### REVISED FINAL FEASIBILITY STUDY ST. LAWRENCE REDUCTION PLANT

Reynolds Metals Co.  
St. Lawrence Reduction Plant  
P.O. Box 500  
Massena, NY 13662  
August 19, 1991

### REVISED FINAL FEASIBILITY STUDY REYNOLDS METALS COMPANY

**RESPONSE TO COMMENTS  
AND  
GUIDE TO REVISIONS IN THE FS REPORT**

**Figure II-1:**

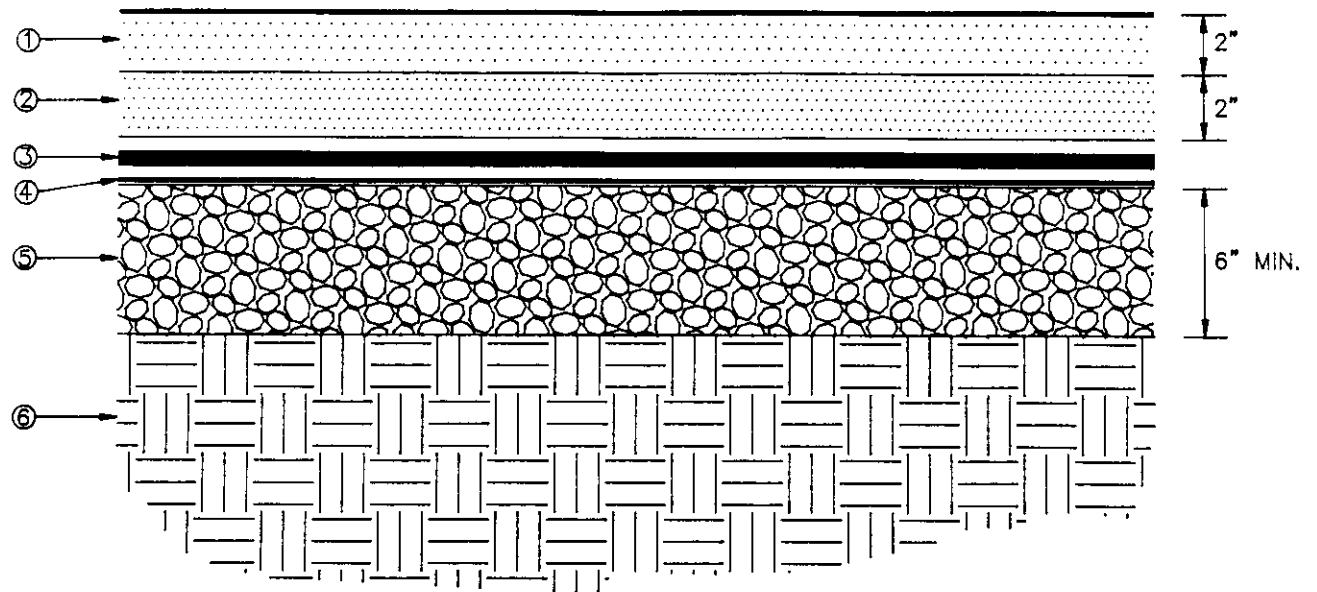
The figure (and accompanying text) has been modified to agree with the regulatory requirements.

**Figure II-4:**

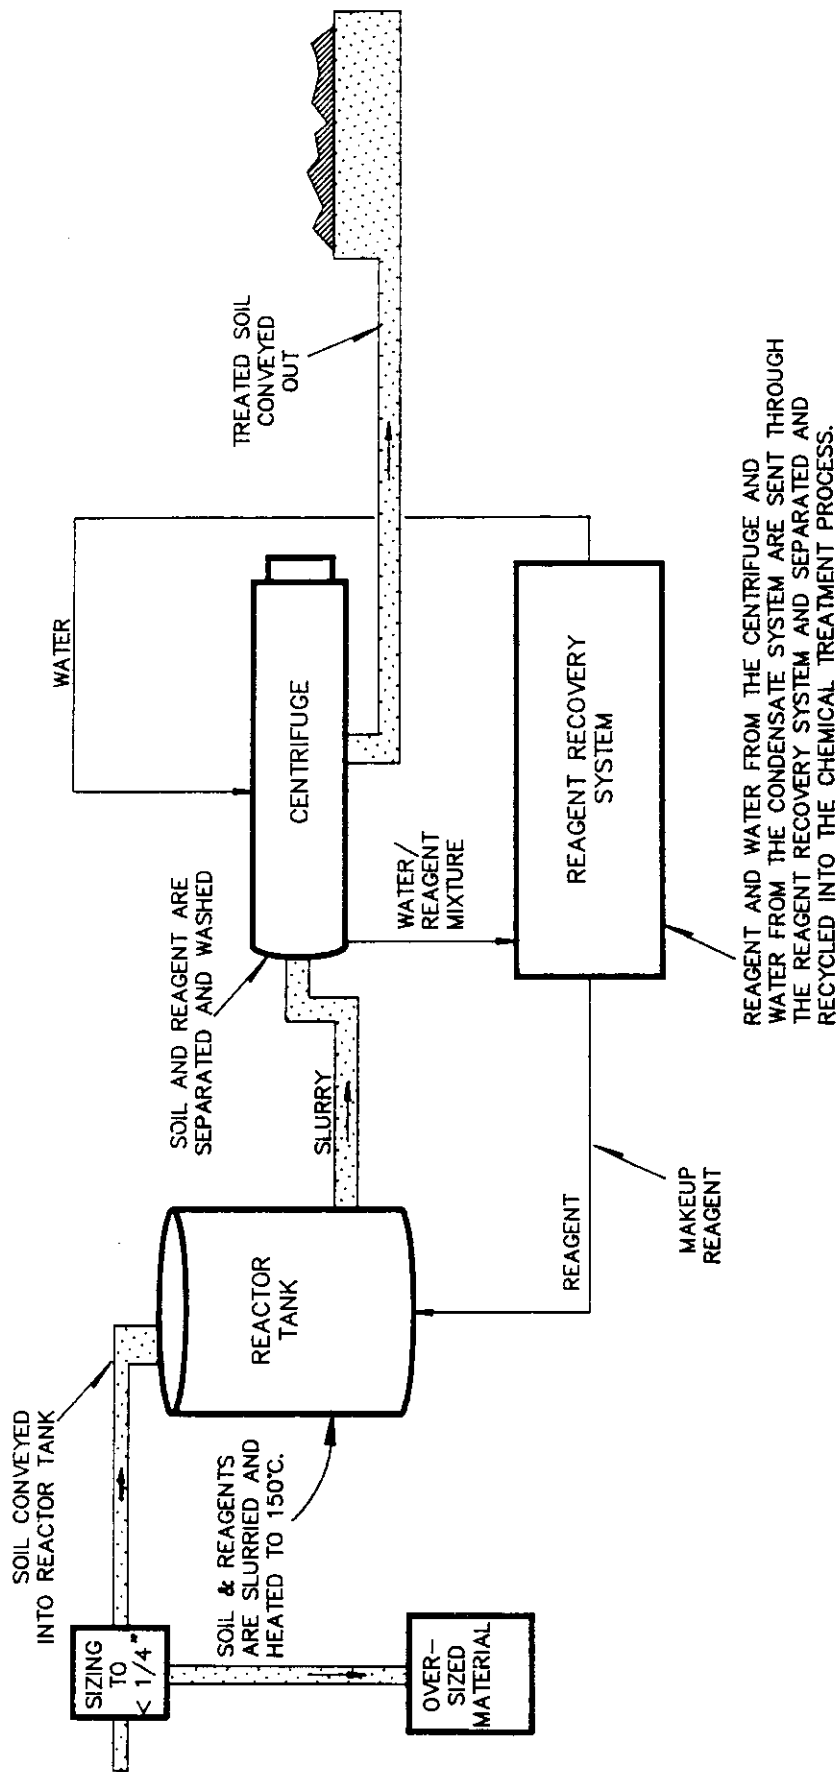
The figure has been replaced by additional details in Appendix E.

FIGURE IX-1

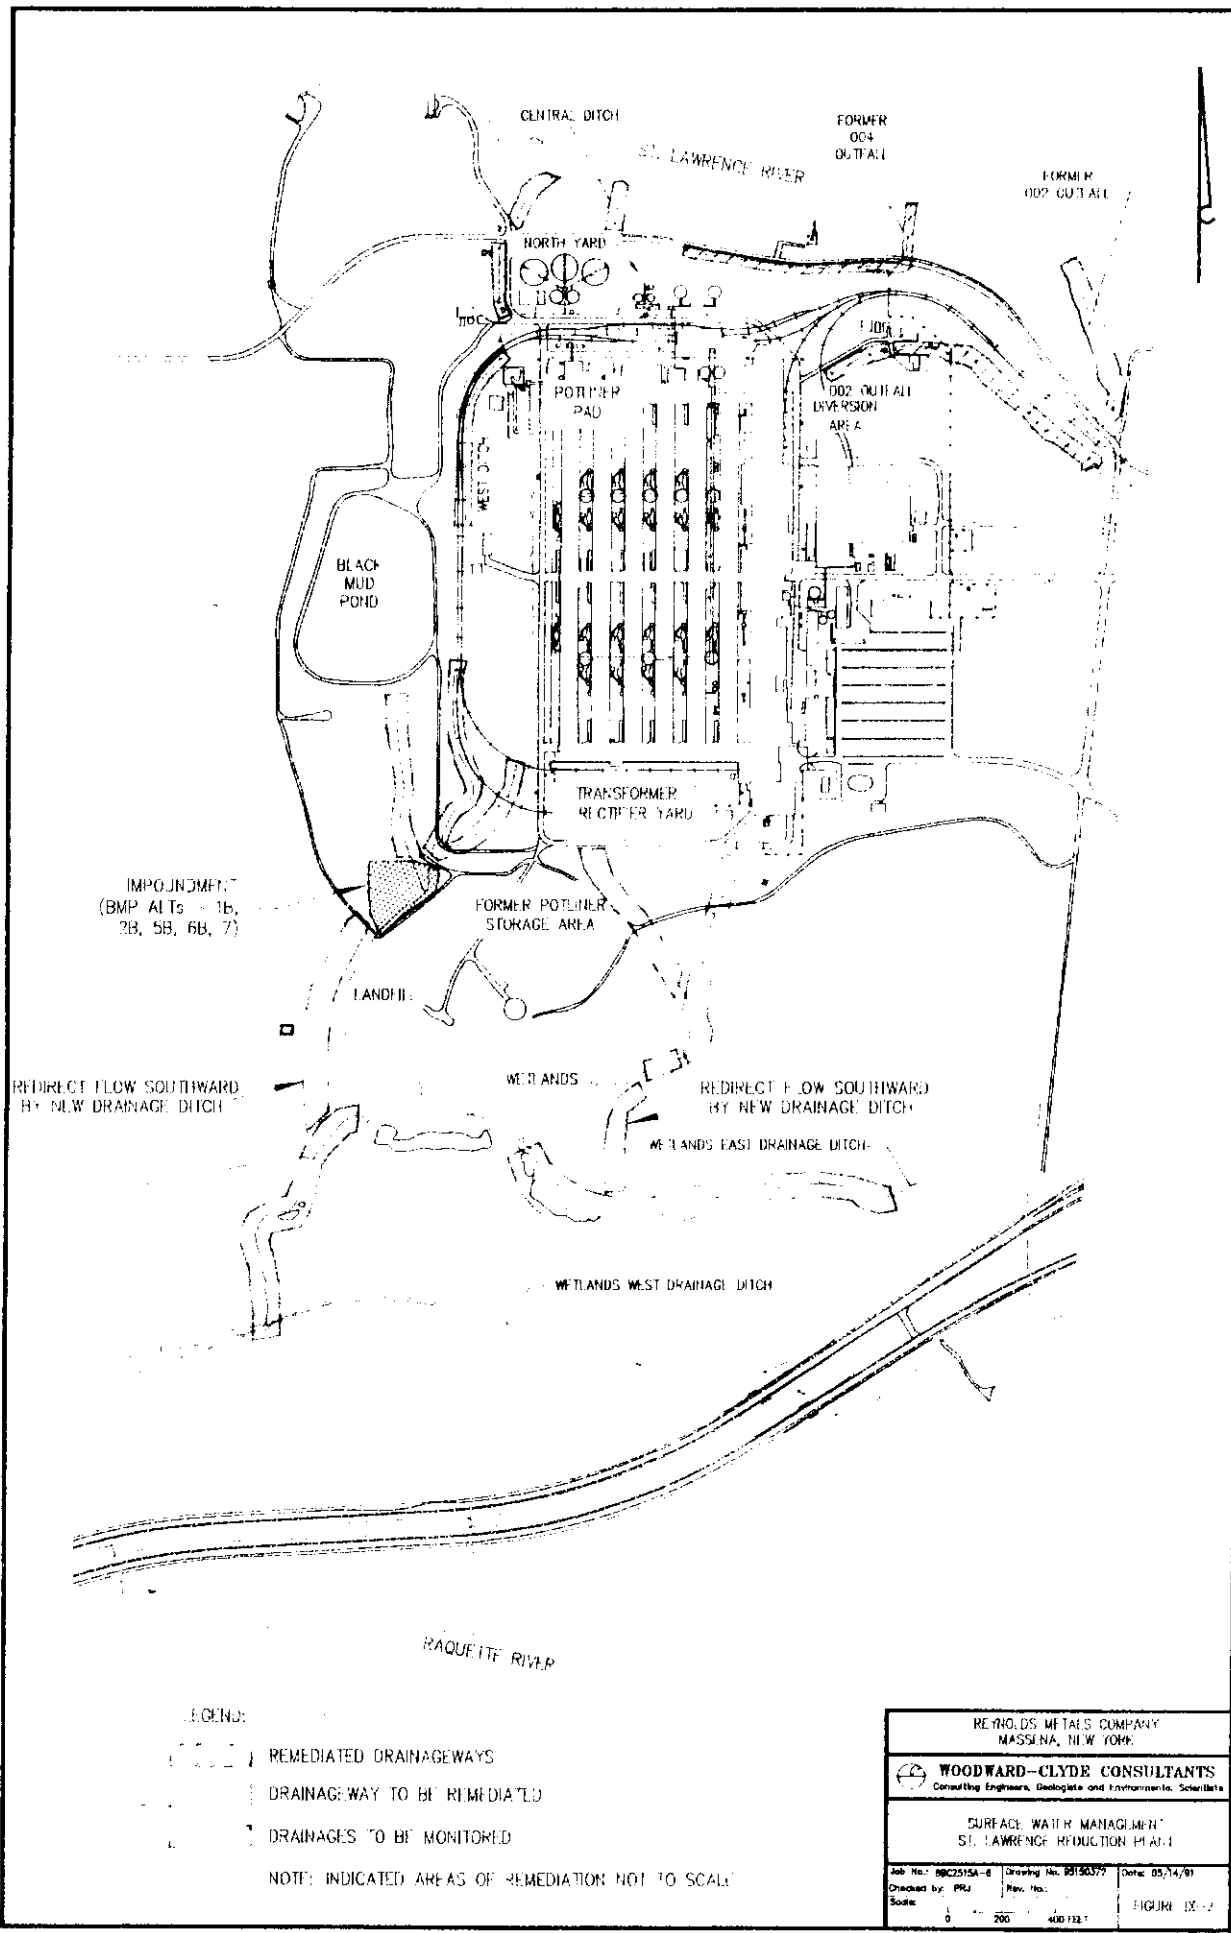
A new figure has been added to Part IX to summarize plant-wide surface water collection/remediation for all alternatives. In all cases where interception trenches (or perimeter drains) have been included in alternatives, they are keyed into low permeability units, since the native soils in the area are of low permeability (glacial till and/or glaciolacustrine clay). Vertical barriers have not been included in any alternatives, as they would impede the collection of groundwater from any interception trenches and minimize the effective drawdown of the local groundwater collection system.
